CITY OF RAPID CITY

RE: Addenda to the City of Rapid City Standard Specifications for Public Works Construction 2004 Edition

Page 2 PW030105-19

TERMINATION MANHOLE

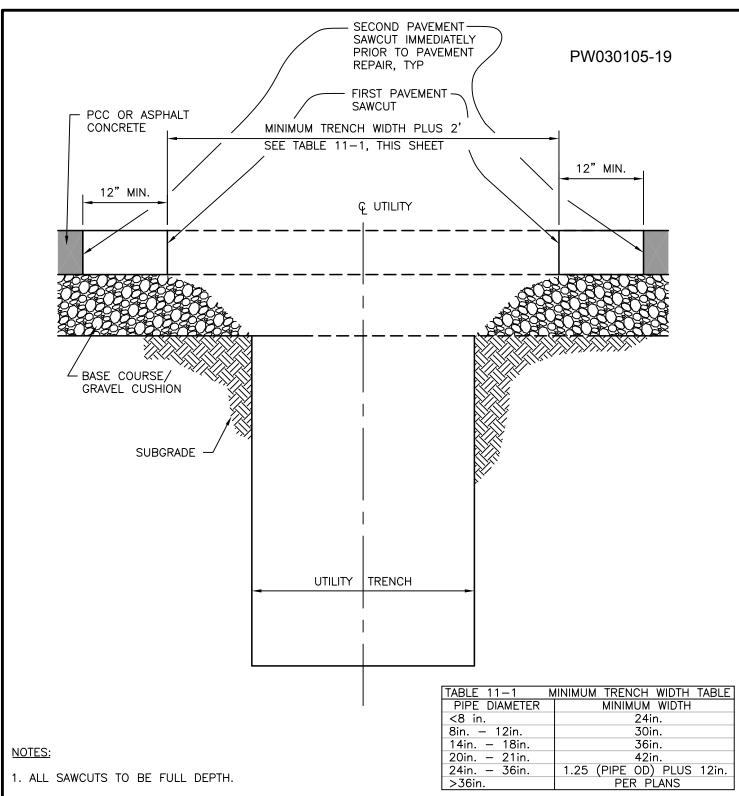
Insert attached Standard Detail 9-13 into the Standard Details.

Reason: A Termination Manhole detail was not previously incorporated in the Specifications.

CITY OF RAPID CITY PUBL	IC WORKS DEPARTMENT
	DATE: 2-24-05
UTILITY TRENCH	SEC. SHT.
PATCH DETAIL	41-1

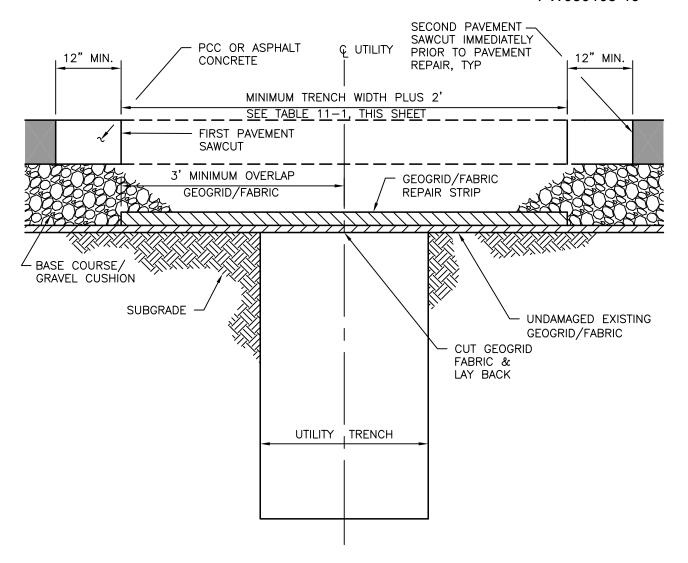
Replace Standard Details **41-1 and 41-2** with the applicable attached details.

Reason: The specified trench width has been modified to minimize the removal limits and decrease the overall pavement patch width.
